# Change Application (Minor Change) Town Planning Assessment 45 Maryland Street, Stafford Heights

BCC DS  
RECEIVED  
05-JUN-2026  
APPLICATION REF  
A007042924

**Figure 1** – Supplementary Deep Planting Location (identified in red) and Required PMT Location (Identified in yellow)  
Source – Gatehouse Architects 2026

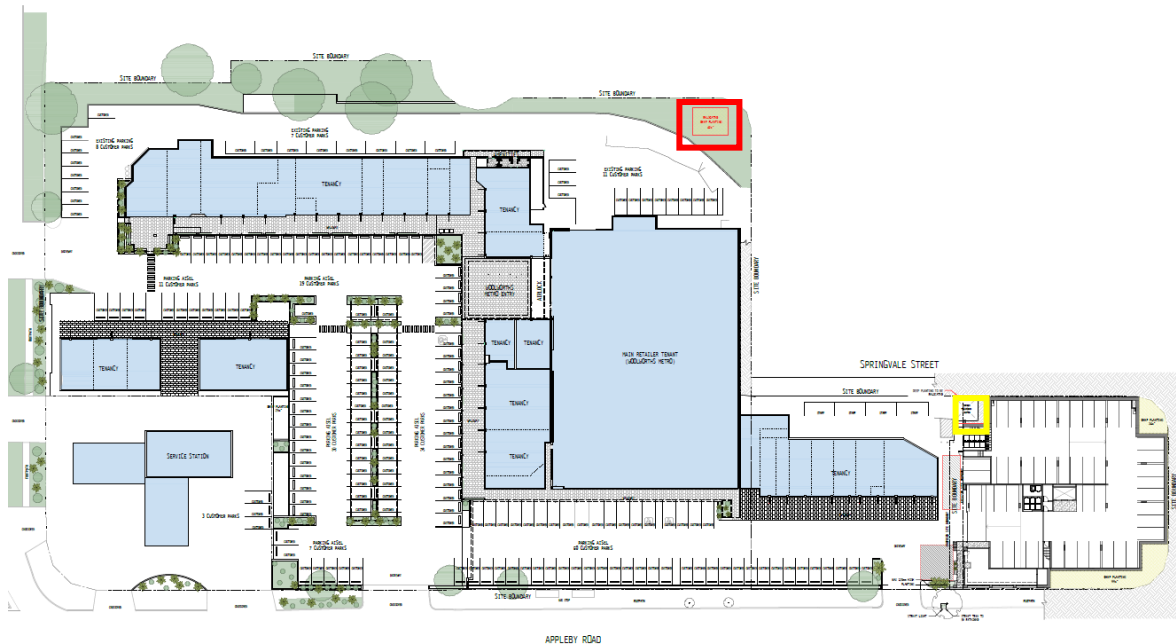
- **Pad Mount Transformer (PMT)** – As part of the detailed design process the Applicant has engaged further with Energex (notwithstanding earlier authority advice on PMTs) to finalise the existing and required electrical capacity for the development. Energex have now advised that a padmount transformer is required and needs to be accommodated in the eastern corner of the site, adjacent to Springvale Street. Refer to **Figure 1**.

The proposed location represents the most appropriate and least impactful outcome, notwithstanding its encroachment into the approved deep planting area. Investigations with Energex and the architect have determined that there are no alternative suitable locations within the site that can accommodate the infrastructure without resulting in greater impacts to building design, access arrangements, or overall functionality of the development.

To balance the provision of the padmount transformer and change to the deep planting, the Applicant proposes provide a new deep planting area within the shopping centre land (which forms a part of the site). The proposed deep planting area is illustrated in **Figure 1** and has been reflected in the updated Landscape Concept Plans included in **Attachment C**. That deep planting area will contain additional large sub-tropical tree planting.

A coordinated and shared whole of site landscaping outcome is appropriate, noting there is no physical barrier between the sites, and several elements are already shared, including vehicular access, external car parking areas, and the service bay. The proposed approach achieves a cohesive and integrated interface, while accommodating essential infrastructure requirements.

- **Deep Planting**– The application proposes a revised deep planting arrangement to accommodate the required padmount transformer on the Springvale Street frontage. In response, supplementary deep planting is introduced within the associated shopping centre site (part of the development approval) to maintain an integrated and high-quality landscaped outcome across the functionally connected landholdings.

**Figure 3 – Rooftop Comparison**  
Source – Gatehouse Architects 2026

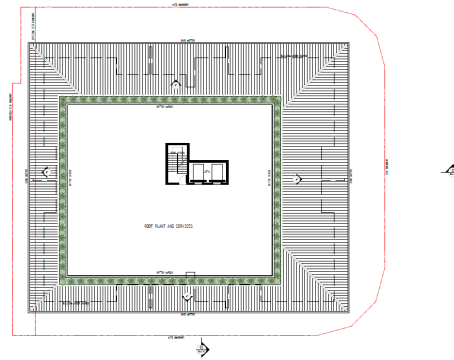
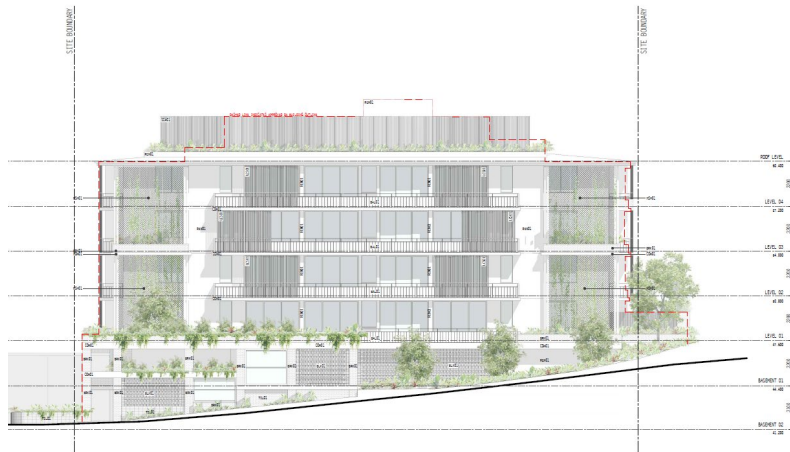
- **Rooftop building services** – The communal roof terrace has been removed to support the accommodation of building services. The area of the roof plant and services is reflected in **Figure 2**. The services will be screened by a vertical batten screen around the perimeter of the services and landscaping. The services have an extent and scale that is coherent with the approved communal roof terrace and therefore will not substantially change the form and scale of the development. Refer to **Figure 3** which includes an outline of the approved development as a comparison to the proposed rooftop services. The landscaping and screening will ensure that the change does not result in a substantially different building appearance.

- **Building Height** – The application maintains the approved maximum building height of 4–6 storeys, with no change to the approved rooftop RL or overall built form height. The approved rooftop communal open space is proposed to be replaced with a screened rooftop building services area to support the operational requirements of the development. The rooftop services area remains coherent with the approved roof form and continues to present as a recessive architectural element.

**Figure 2 – Proposed Basement 02 Floor Plan (Key Changes identified in Green)**  
Source – Gatehouse Architects 2026

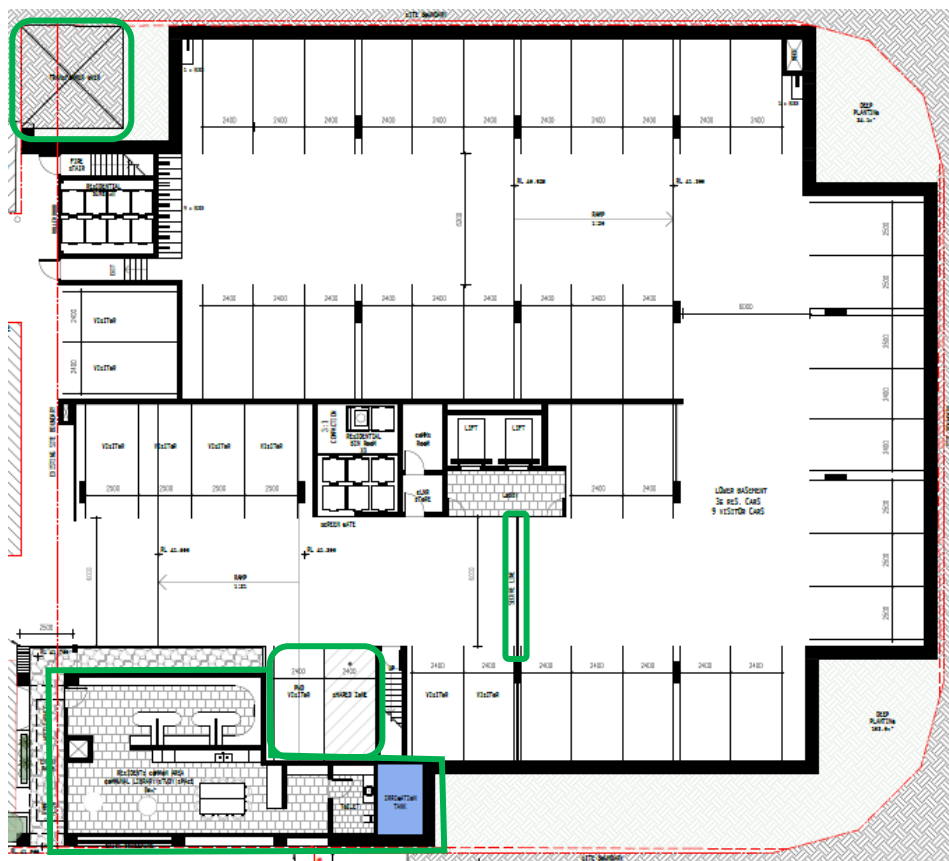
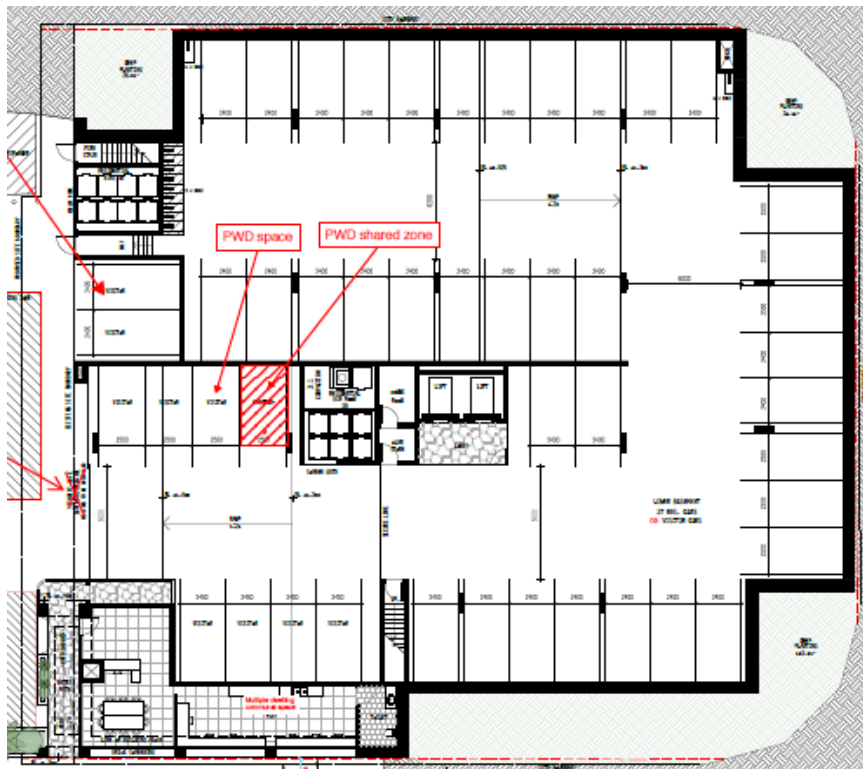
Basement 02 Floor Plan Changes:

- Resident car parking changed from 37 resident spaces to 35 spaces (on basement level 02), as a consequence of changes to the communal recreation space at this level.

The development provides a total of 75 resident car spaces, which represents a minor alternative outcome (2 spaces) to the car parking rate under the TAPS Policy.

**Figure 4 – Proposed Basement 01 Floor Plan**

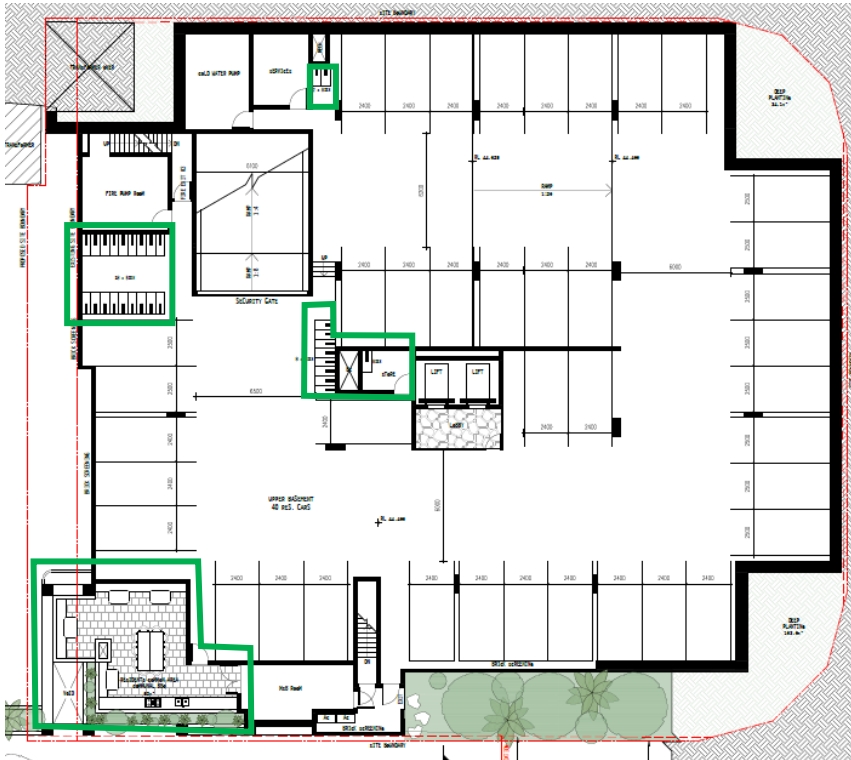
#### Basement 01 Floor Plan Changes

- Rearrangement of bicycle parking provision to respond to the introduction of the new communal open space area.
- Minor reconfiguration of storage and servicing areas to support the revised basement arrangement.

- **Communal Open Space** – The application proposes a revised Communal Open Space arrangement, involving the removal of the rooftop communal open space and the addition of a new 52m<sup>2</sup> Basement Level 01 communal open space on Apply Road frontage. This space is provisioned with a barbeque and kitchenette facility and numerous seating options. Further, the new communal open space extends over the void area, which is open to the sky and will facilitate access to natural light, and breezes for the new area
